Request for Class II Permissive Change

FCC ID: **YZZHT701V21** Data: Sep. 17th, 2013

Original mainboard photo view

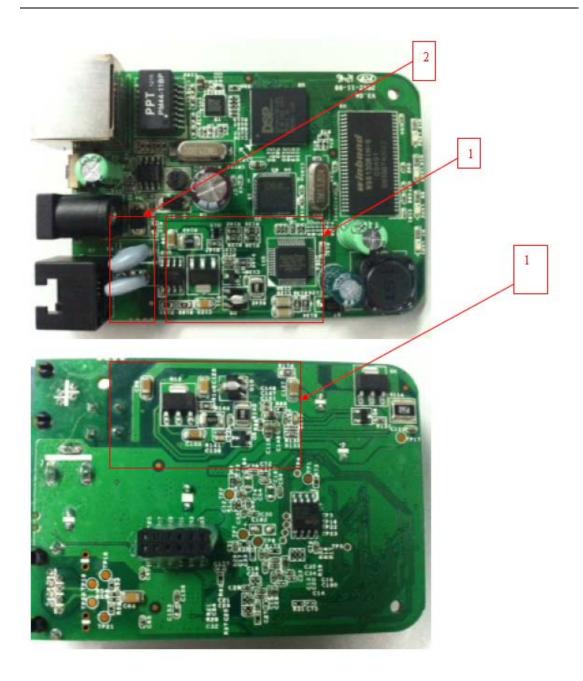
- 1. Upgraded main board hardware version from HT701 V2.1A to HT701 V3.0A;
- 2. Changed component layout& PCB layout, we only replace an integrated chip (N681622YG) by discrete circuit for better performance(see arrow 1);
- 3. Change PTC from 9 ohm to 50 ohm(see arrow 2);
- 4. Changed brand of network transformer;
- 5. Added an power adapter(Model:WCF1200050A1BA) and has the same electrical specification with original power adapter.
